Subject: POOR A/C PERFORMANCE	Bulletin No: 07-004/15
	Last Issued: 11/25/2015

BULLETIN NOTE

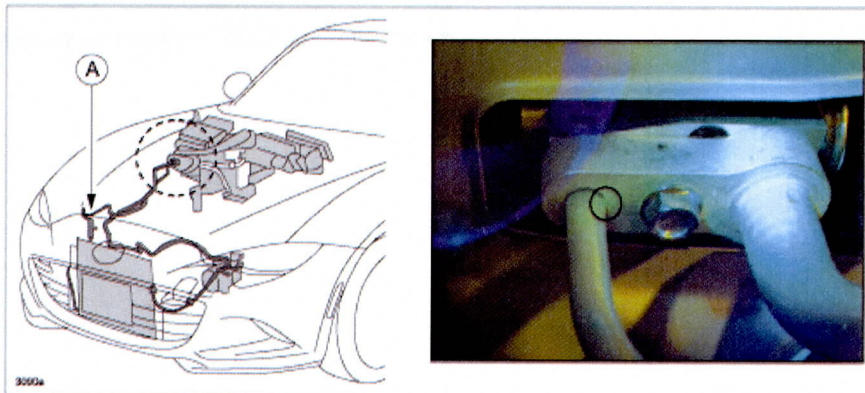
Some vehicles may experience poor A/C performance due to a slow refrigerant leak from the O-ring groove on the cooler pipe (high pressure side) at the expansion valve.

1. Verify customer concern.
2. Using a refrigerant leak detector or a black light, determine where the leakage is coming from.
 - If the leak is detected at the connection where the "Cooler Pipe (HI) C" connects to the expansion valve, replace the "Cooler Pipe (HI) C" (A) with a new one according to the instructions on MS3 online or the Workshop Manual (section 07-11 REFRIGERANT LINE REMOVAL/INSTALLATION).
